# SERVICE BULLETIN

## CRACKS, WEAR AND DISTORTION ON THE CARBURETOR FLANGE ON ROTAX® ENGINES TYPE 912 AND 914 (SERIES)

**SB-912-030 R1**

**SB-914-019 R1**

Fig. 1

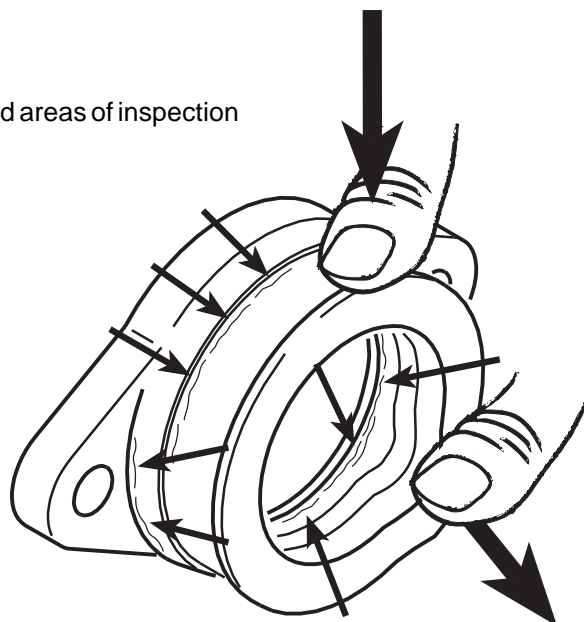
Inspection of the carburetor flanges in accordance with the relevant Maintenance Manual and the information contained in Section 4) Appendix, Figure 1 .

fig. 4

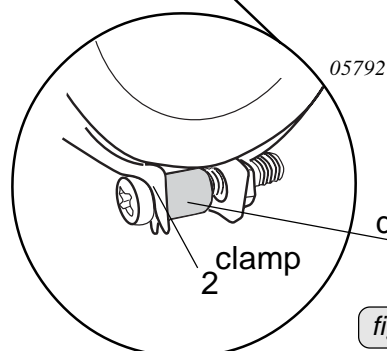
Replacement/Installation of the carburetor flanges in accordance with the relevant Maintenance Manual. Tighten clamp (2) of the carburetor flange part no. 267788 with tightening torque 2.5 Nm (22 in.lb ) (see fig. 4) .

fig. 3

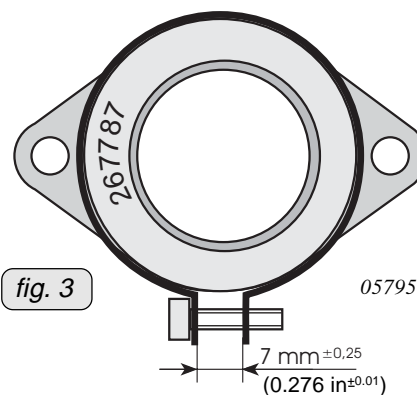
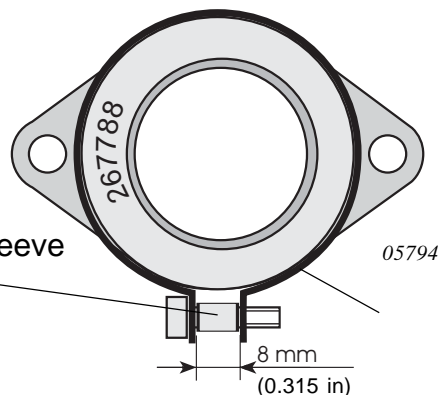
Introduction of a optimized carburetor flange with improved strength properties and spacer for the clamp. One or more of the following could result in increased stress and consequently in damage of the carburetor flange assembly:

\* ▲ **WARNING:** Due to differences in spacing **don't use** the distance sleeve (1) included in delivery of the carburetor flange part no. 267788 in combination with the carburetor flange part no. 267787.

▲ **WARNING:** **Don't use** aluminum insert included in delivery of the carburetor flange part no. 267785 or 267780 in combination with the carburetor flange part no. 267788.

- If necessary remove the carburetor flange as per the following instructions.
- If replacement of part no. 267788 is necessary **both** carburetor flange are to be replaced per engine. (Do not mix new style with old style on the same engine)
